SERVICE BULLETIN
CHECKING OR REPLACEMENT
OF FLEXIBLE FUEL LINE
FOR ROTAX® ENGINE TYPE 912 (SERIES)
SB-912-054 UL

CHECKING OR REPLACEMENT OF FLEXIBLE FUEL LINE FOR ROTAX® ENGINE TYPE 912 (SERIES) SB-912-054

Checking or replacement of flexible fuel line for ROTAX® engine type 912 series.

Fig. 1

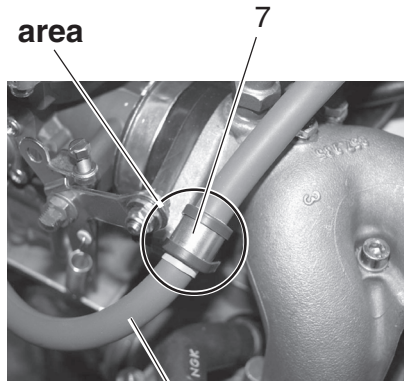
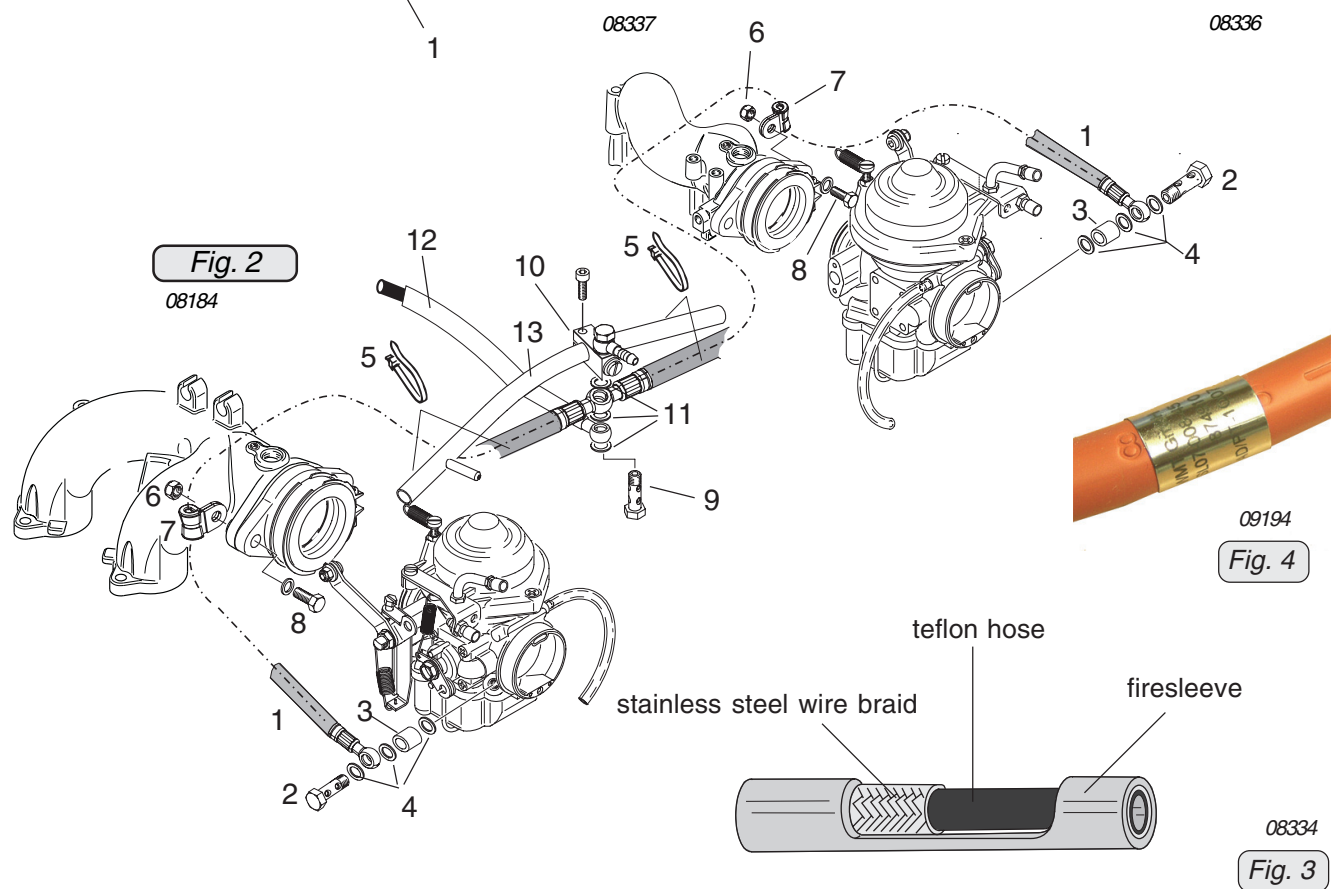
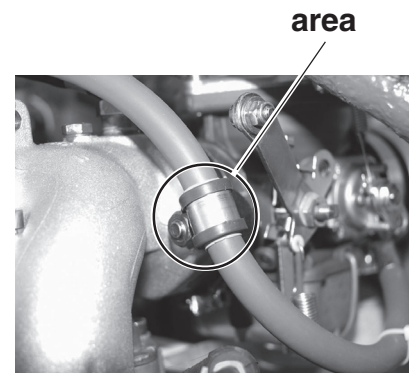
Visual inspection of the fuel line (1) in the area clamp (7) and both ends of the yellow protection cover. (see Fig. 1)

◆ **NOTE:** A possible crack can be observed by careful bending of the fuel line. If you notice cracks or porosity then you need to replace the fuel line in accordance section 3.1.2.

2. Install both cable clamp (7) in accordance with Fig.1 on the fuel line.
